Customer : CU-DAR001 Dart Helicopters Services	Drawing Name : 350 SKIDTUBE ASSEMBLY RH
Job Number : 40699	
Estimate Number : 10265	
P.O. Number :	Part Number : D350636012
This Issue : 22/07/2008 S.O. No. :	Drawing Number : D2750 UNDER REVIEW — UPDATE PER DSI 9413 Ret 03-07-22
Prsht Rev. : NC	Project Number : N/A
First Issue : / / Type : SKIDTUBES	Drawing Revision :
Previous Run : 39764	Material :
Written By :	Due Date : 10/08/2008 Qty: 1 Um: Each
Checked & Approved By : <u>JLD 08.7.22</u>	
Comment :	
Est Rev:I 02.09.25 Rearranged procedure steps KJ	
Est Rev:J 06-03-29 As per Rev D EC	
Est Rev:K 06-07.13 As per dsi9343 EC	
Est Rev:L 07-07-28 Added SS Wearplates(Rev E) JLM	
Verified By:EC	
Est Rev:M 08-04-22 update steps 4,13 DD verified by:EC

DART SERVICE INSTRUCTION

TO AMEND INSTALLATION INSTRUCTIONS IIN-D350-636 REV E

A	NEW ISSUE	PH	08.05.14
REV.	DESCRIPTION	BY	DATE
DESIGN	PH	DART AEROSPACE USA, INC PORT HADLOCK, WA	
DRAWN	PH		
CHECKED		DRAWING NO.	REV. A
MFG. APPR.	N/A	DSI 9413	SHEET 1 OF 3
APPROVED		TITLE	SCALE
DE APPR.		WEARSHOE MODIFICATION	NTS
DATE	08.05.14	COPYRIGHT © 2008 BY DART AEROSPACE USA, INC <small>THIS DOCUMENT IS PRIVATE AND CONFIDENTIAL AND IS SUPPLIED ON THE E

FIGURE 1 - WEARPLATE MODIFICATION

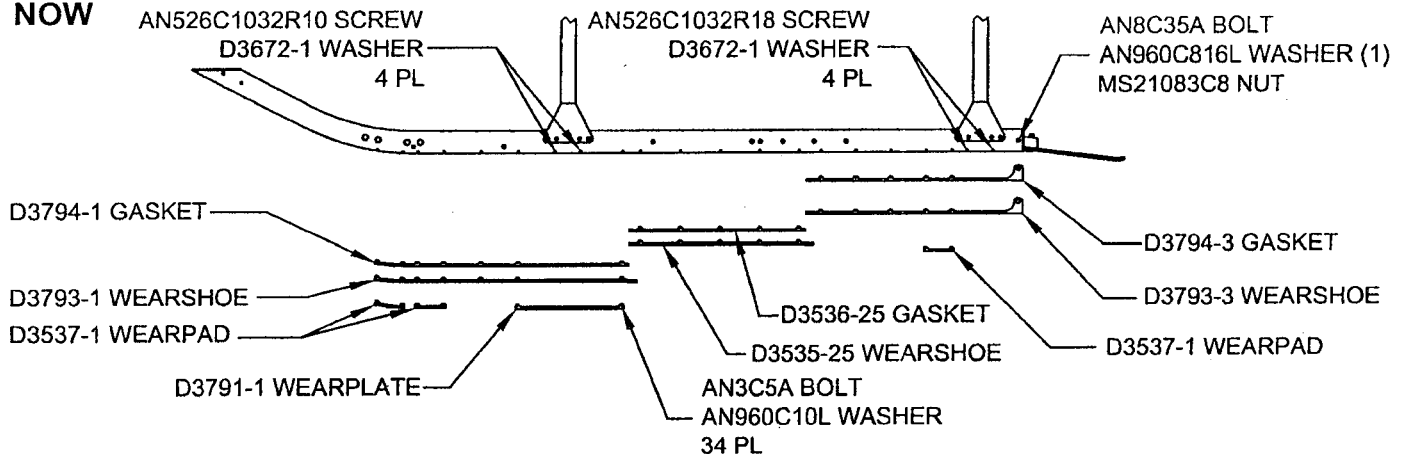
THE WEARPLATES ON D350-636-011/-012/-013/-014 SKIDTUBES AT CHG 004 (AND LATER) HAVE BEEN MODIFIED AS SHOWN IN FIGURE 1 BELOW TO ELIMINATE THE POSSIBILITY OF INTERFERENCE BETWEEN THE WEARPLATES AND CROSSTUBE SADDLES AT INSTALLATION. THERE IS NEGLIGIBLE WEIGHT CHANGE ASSOCIATED WITH THIS MODIFICATION.

(AN526C1032RXX SCREW LOCATIONS NO LONGER USED TO MOUNT WEARSHOES)

TO INSTALL THE DSI 9413-011 KIT, REMOVE THE EXISTING WEARSHOES/GASKETS UNDER THE FWD/AFT SADDLES AND INSTALL NEW WEARSHOES/GASKETS AS SHOWN IN FIGURE 1. PLUG UNUSED HOLES WITH AN526C1032RXX SCREWS AND D3672-1 WASHERS. INSTALL SCREWS WITH SIKAFLEX -241/-291 OR PROSEAL 890 OR MIL-S-8802 CLASS 'B2' SEALANT AS SHOWN IN FIGURE 1. NOTE: SOME OF THE PREVIOUSLY INSTALLED HARDWARE IS NO LONGER REQUIRED.
